Heritage Preservation Commission

Item: 5.A.

Item Name: 262 Lake Street - Amendment to Site Alteration Permit (HPC No. 2025-13)

KALORAMA COTTAGE ADDITION
AND REMODEL
262 LAKE STREET EXCELSIOR, MN 55331

Sheet No.
A203

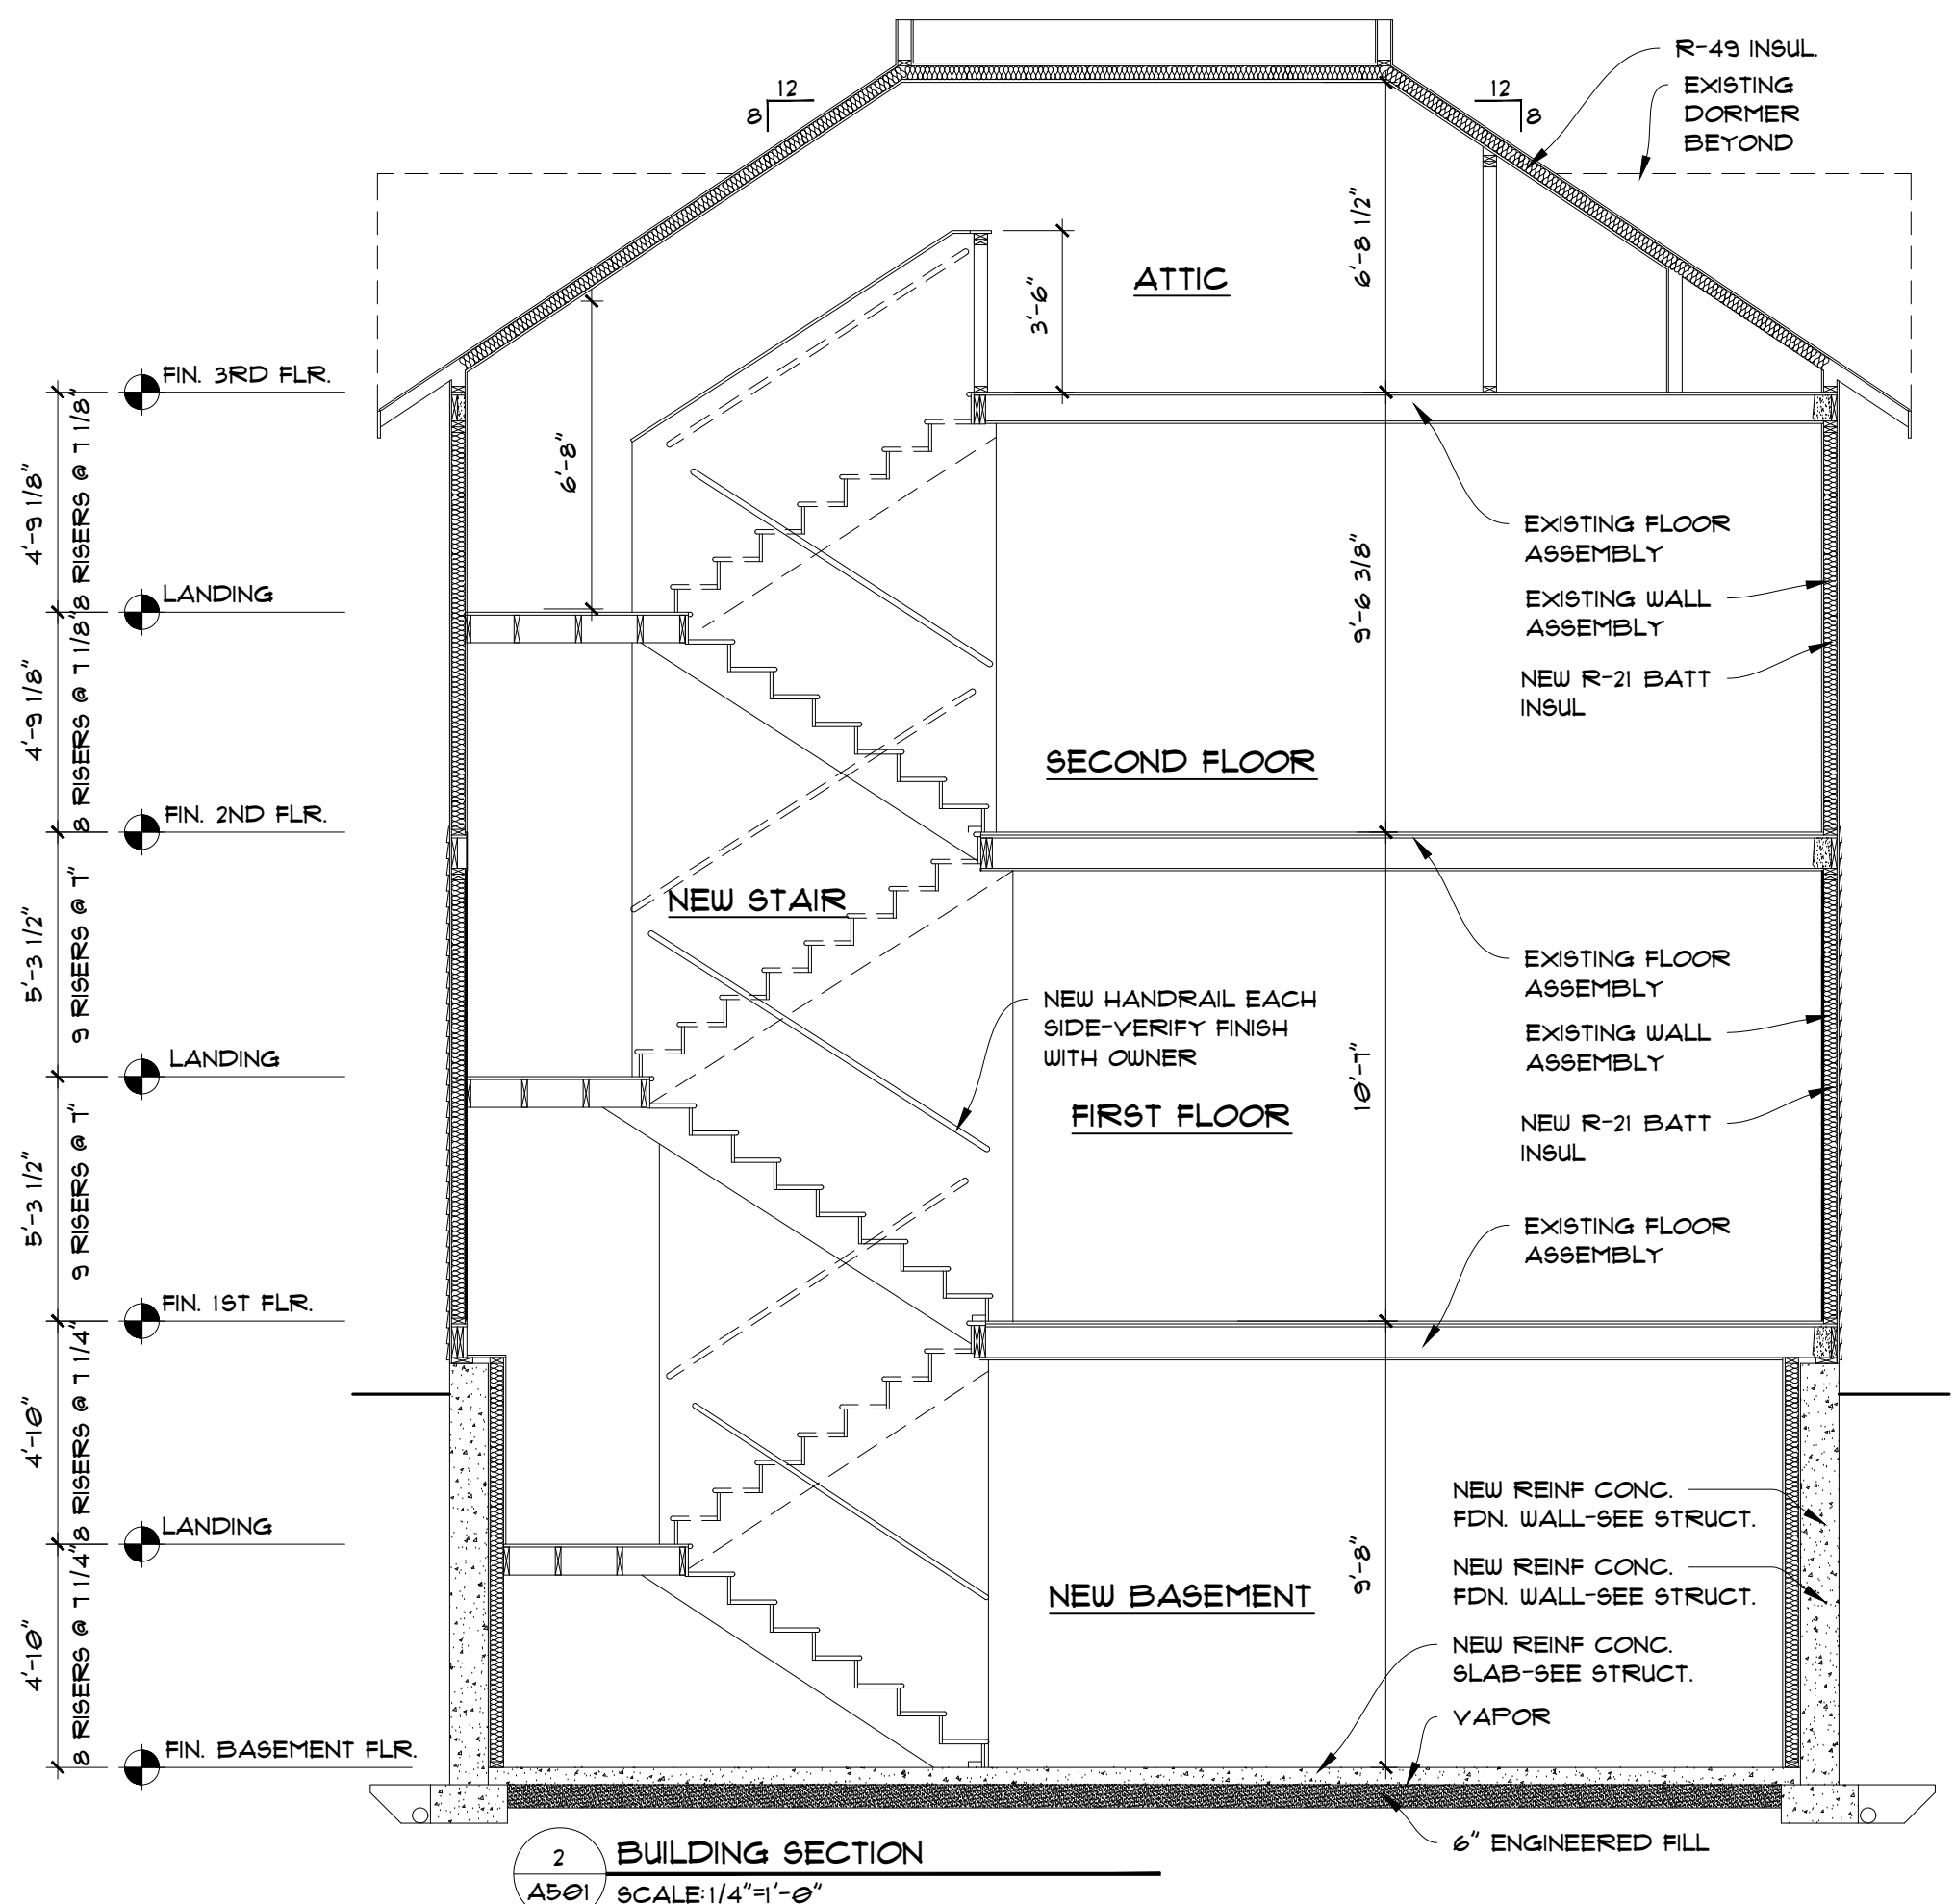
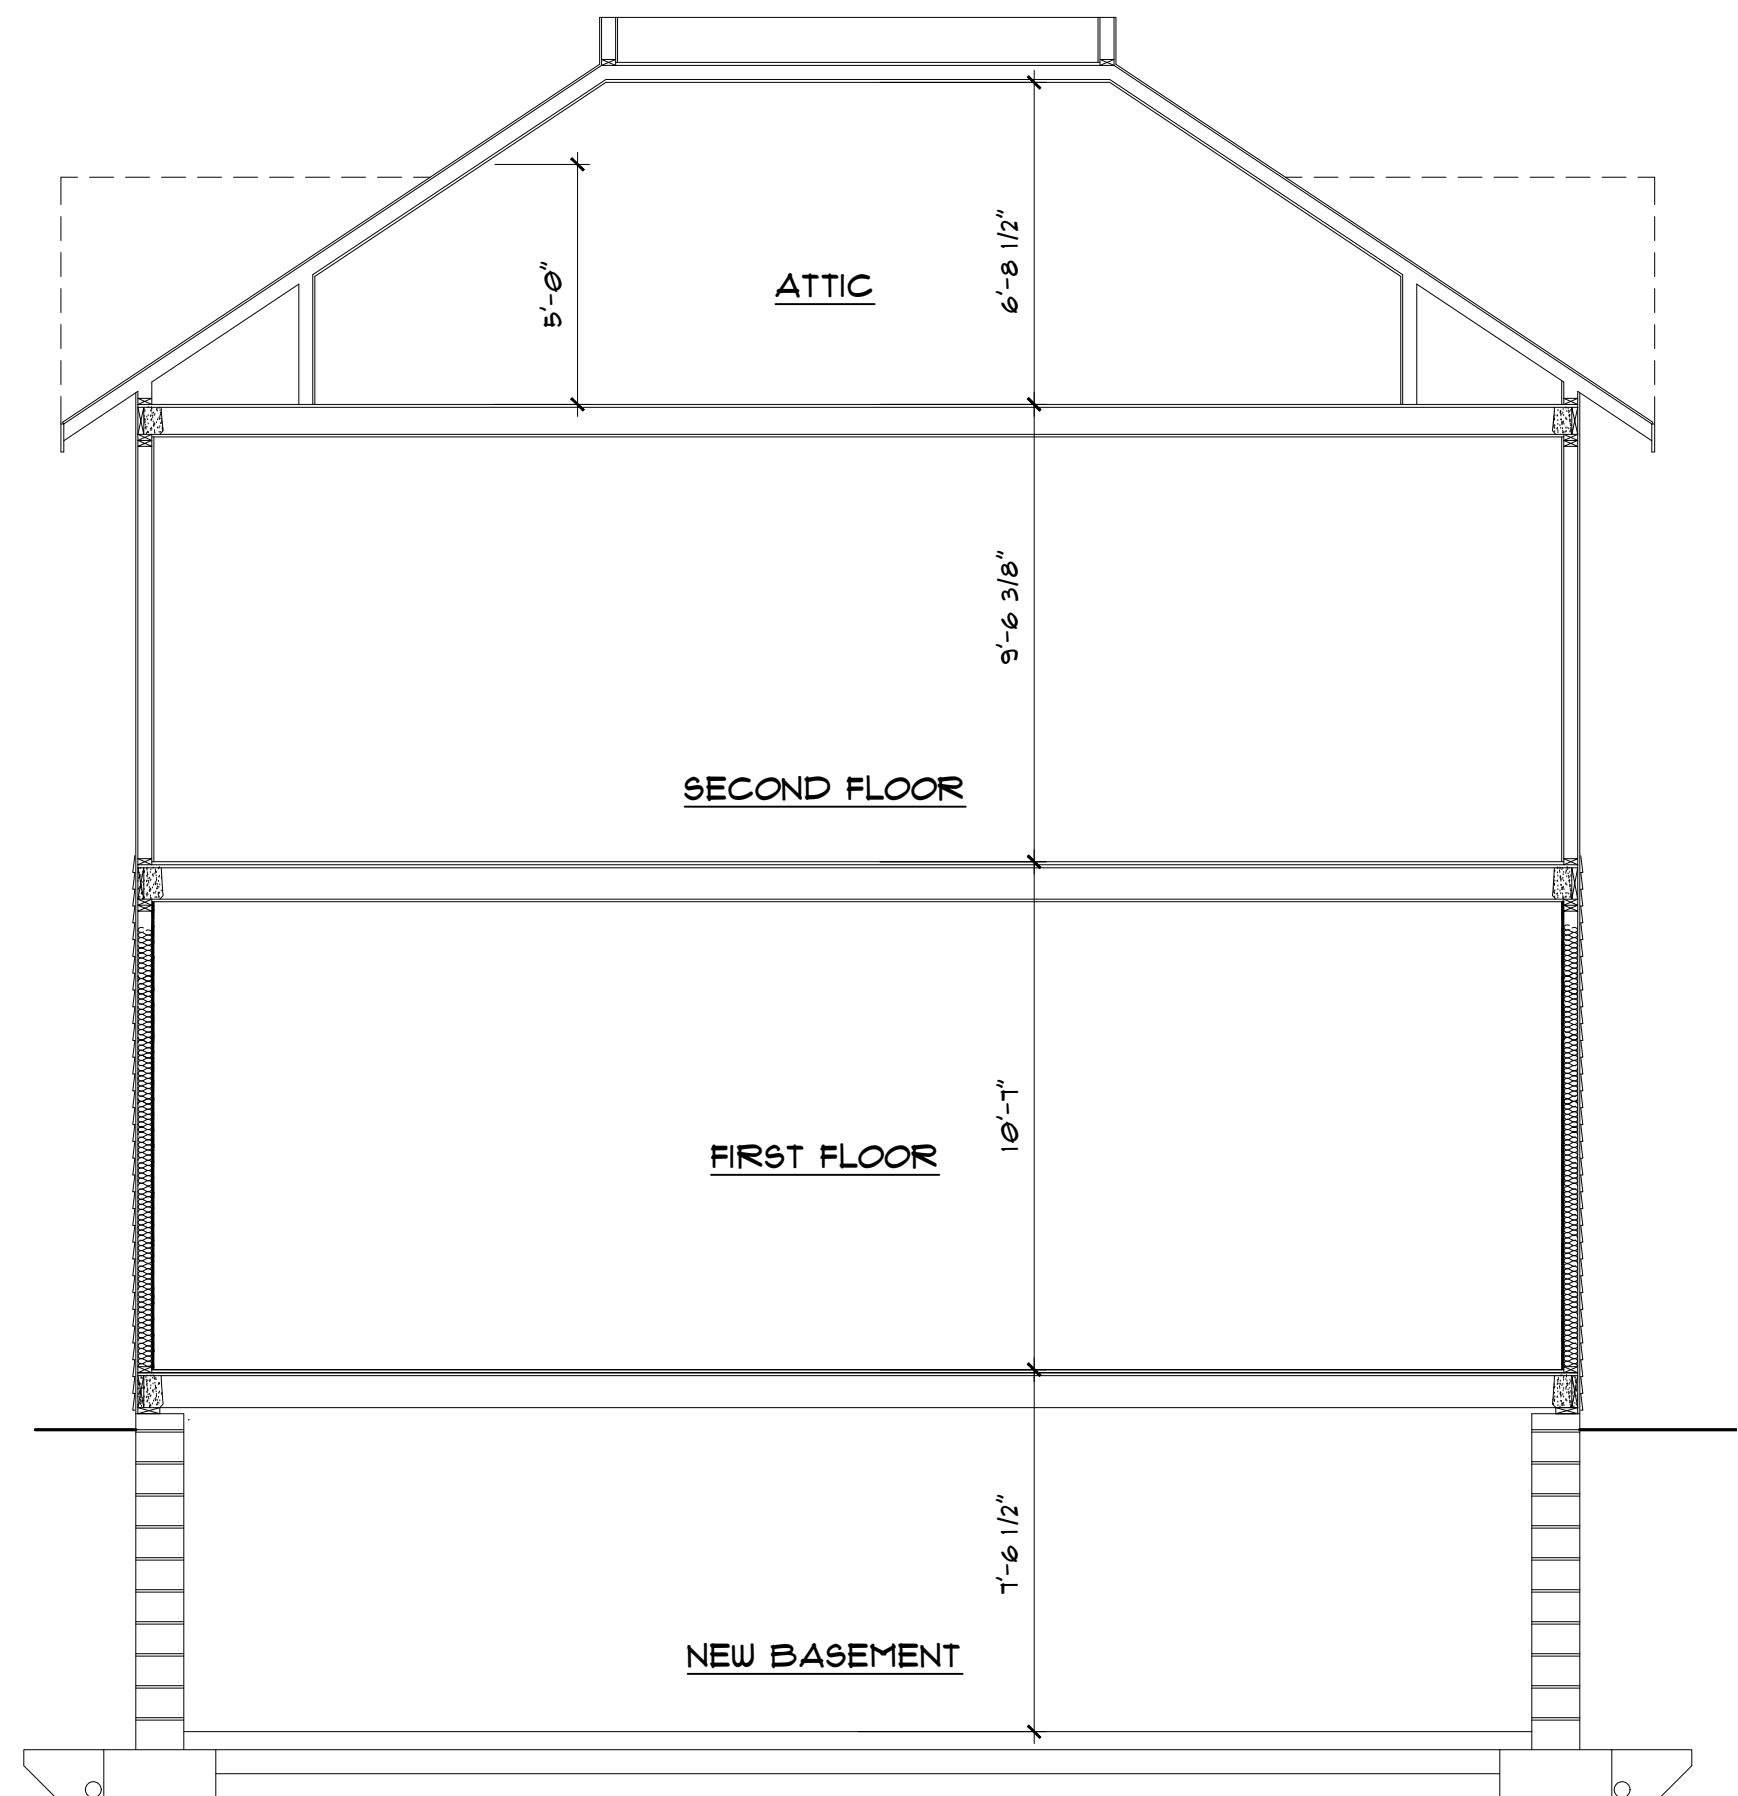
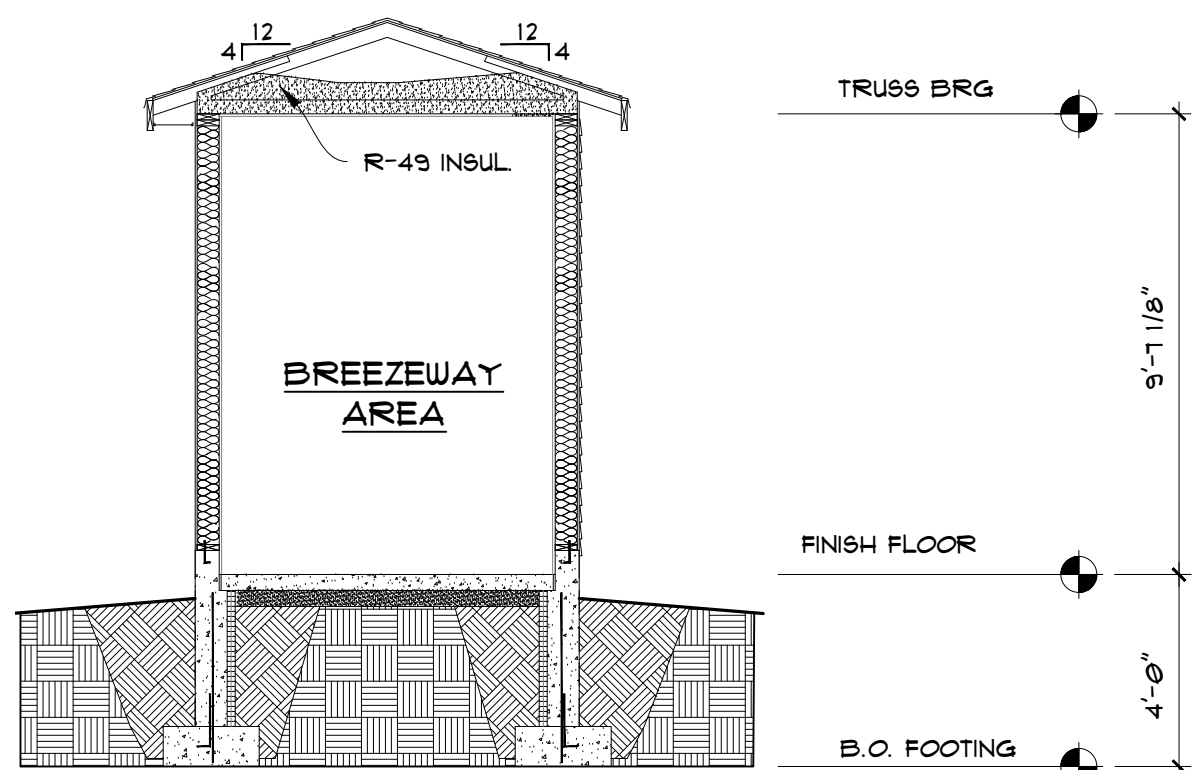
2. The garage height is different from approved plans. The garage height was approved for 24'8" (measured from grade) and is currently 27' at the ridge (measured from grade). Plans approved by the Heritage Preservation Commission (HPC) indicated 24'8"; plans with building permit showed 24'8" and 26'.

The construction plans, A501, describing how to build the garage did have a total height of 26’ 10”. The garage was built according to the plan. The total height is 26’. We dropped the height inside the garage by 10” to reduce the over-all garage height. We now have minimal clearance inside the garage for an opener, etc.
